Roof service finishes / return crates / contact shadows

JW-SAK-ATM-01 / REV B / 24 OCT 2026 / CAD mm / fixed exterior and working routes retained

Counter additions / retained equipment / chiller merchandising

AUDIT BEFORE CONSTRUCTION

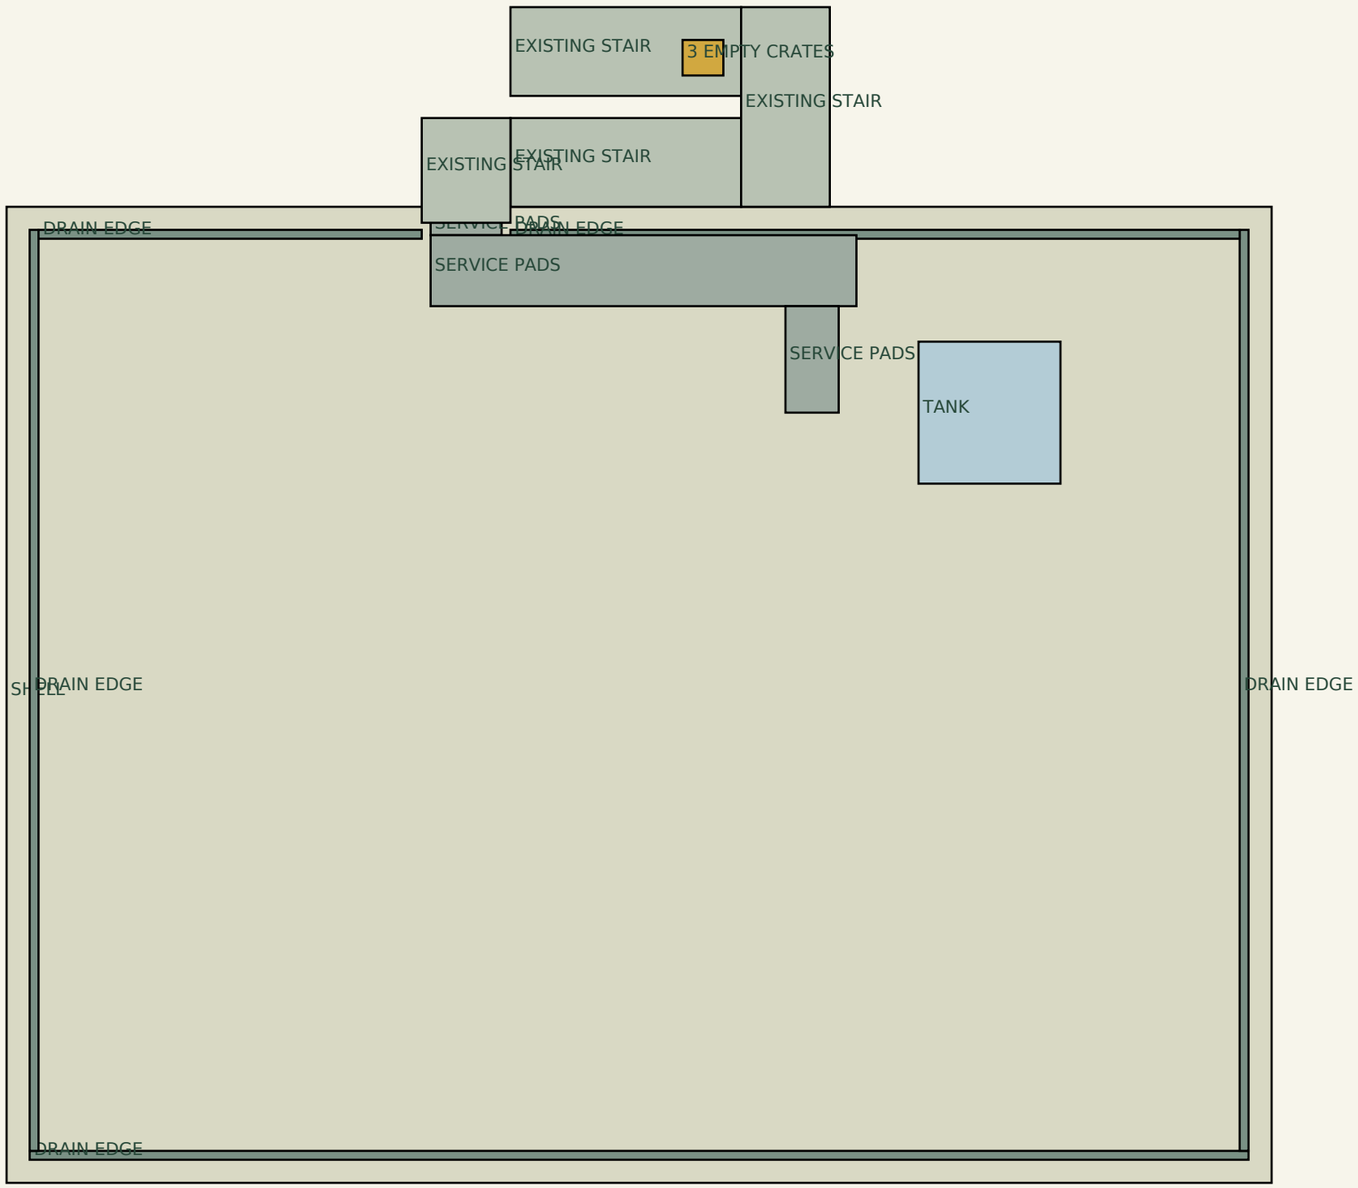
Service pads:20 thick,400 pitch,20 joints.

800 wide main route;600 final approach to steps.

Dark edge finish:100 wide; gate remains clear.

Crates:460 x400 x280,3 high; base +40.

Crate top +880; underside >=+1413.

Over300 vertical clearance; no delivery intrusion.

Soft contact at tank feet and stair posts.

Contact opacity0.18, +1.5mm, depthWrite=false.

RETURN CRATE ELEVATION

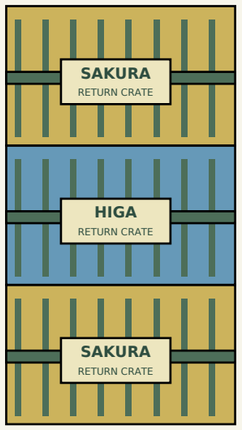
460 x280 each / three stacked

Top +880 / apron +40

Original Sakura / Higa marks

INVENTORY / CORRECTIONS

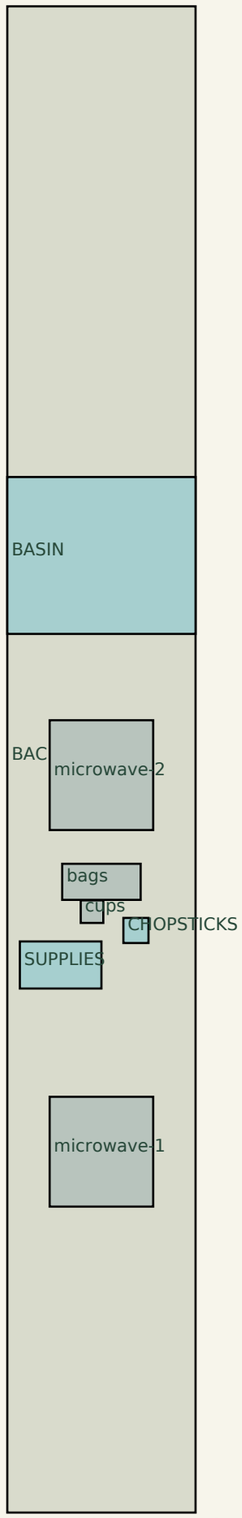
Coin tray, cups, bags, chopsticks and gum already exist.

Retain them; no duplicate tray or second gum display.

Chopsticks:clear acrylic cup; shift80mm to clear bags.

New divided holder:260 x150 x140, top +920.

Oden tag:100 x65; bottom1010; X11296,D4670.

Original oden vat remains on the FRONT counter.

White placeholder is the handwash basin, not oden.

Replace basin within its600 x500 x90 envelope.

Faint cyan chiller back/shelves; packaging unchanged.

Three rice balls rotate -2,+3,-2.5 degrees.
